METROPOLITAN GOVERNMENT OF NASHVILLE AND DAVIDSON COUNTY

STAFF RECOMMENDATION 1315 Gartland Avenue April 22, 2020

Application: Violation/Show Cause; New Construction--Addition
District: Lockeland Springs-East End Neighborhood Conservation Zoning Overlay
Council District: 06
Base Zoning: R6
Map and Parcel Number: 08309006400
Applicant: Natasha Corrieri
Project Lead: Paul Hoffman paul.hoffman@nashville.gov

Figure 2: New dormer as drawn and approved.

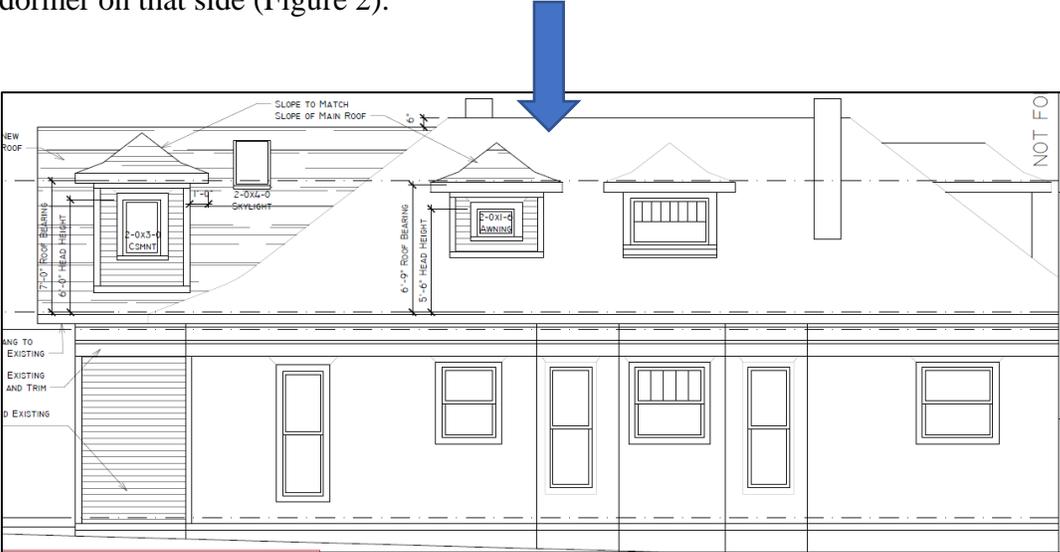
The dormer was approved with its ridge height and eave height in line with the existing dormer on that side (Figure 2).

Figure 5: As-built drawing of new dormer, indicating the 10.5 inch difference in height and smaller window.

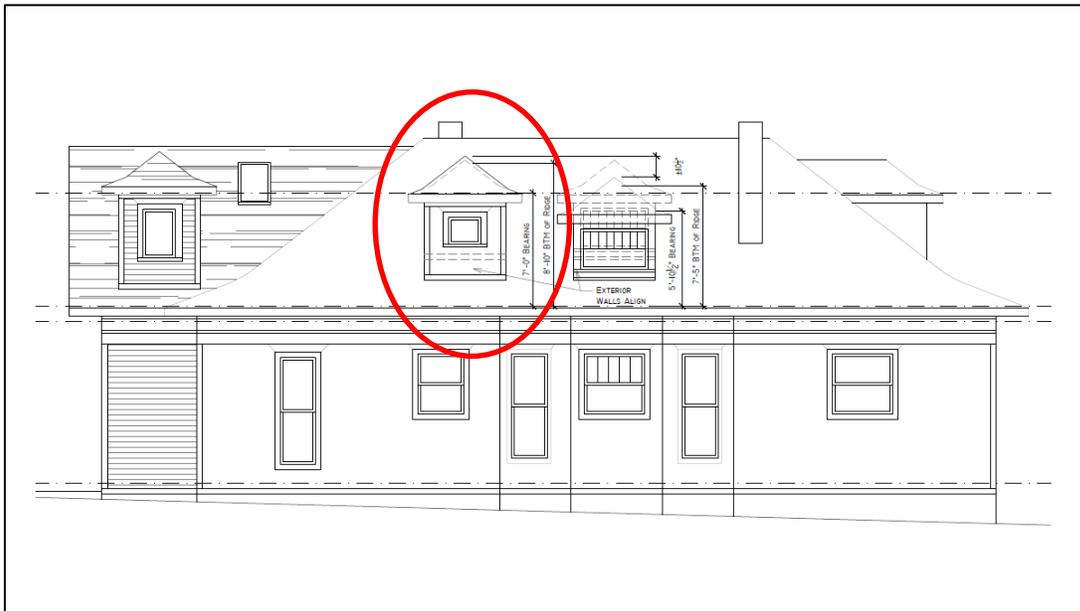
The new dormer houses a shower. During inspection by Metro Codes, the plumbing inspectors required head clearance in this location to be seven feet (7'). The hip of the existing dormer is at approximately six feet (6'). To meet this clearance height, the new dormer was built approximately ten and a half inches (10 ½") taller than the historic dormer (Figures 3-4).

In addition, the window installed is smaller than the one approved. Typically, the face of a dormer is primarily glazing, as evident on the historic dormer to the right. A window smaller than the historic dormer window was approved; however, the window installed is smaller still.

constructed, the dormer is taller than the historic dormer, a condition that is not present on this or similar historic houses and the window is significantly smaller than the historic example. The inappropriate size of the dormer is accentuated due to its location on the historic roof form, rather and its proximity to the historic dormer.

Section II.B.5 for Roof Shape states the new roof forms shall not contrast greatly with the roof shape and orientation of existing roofs. Section II.B.10 for Additions requires that new side dormers shall be compatible with the scale and design of the building, generally matching the form and scale of existing dormers on the building. As the new dormer is located on the historic roof form and not an addition, does not match the height or eave height of the historic dormer, and has a window significantly smaller than the historic dormer, the current dormer does not meet these sections of the guidelines.

Staff finds the dormer does not meet section II.B.5 for roof shape or II.B.10 for additions. Staff recommends that the dormer be revised to reflect the dimensions and placement of the approved design or removed.

Recommendation: Staff recommends that the new dormer be reconstructed to match the dormer permitted by Preservation Permit 2019-058323, within sixty days (60) of the date of this hearing or removed and the original roof repaired within sixty days (60) of the date of this hearing.
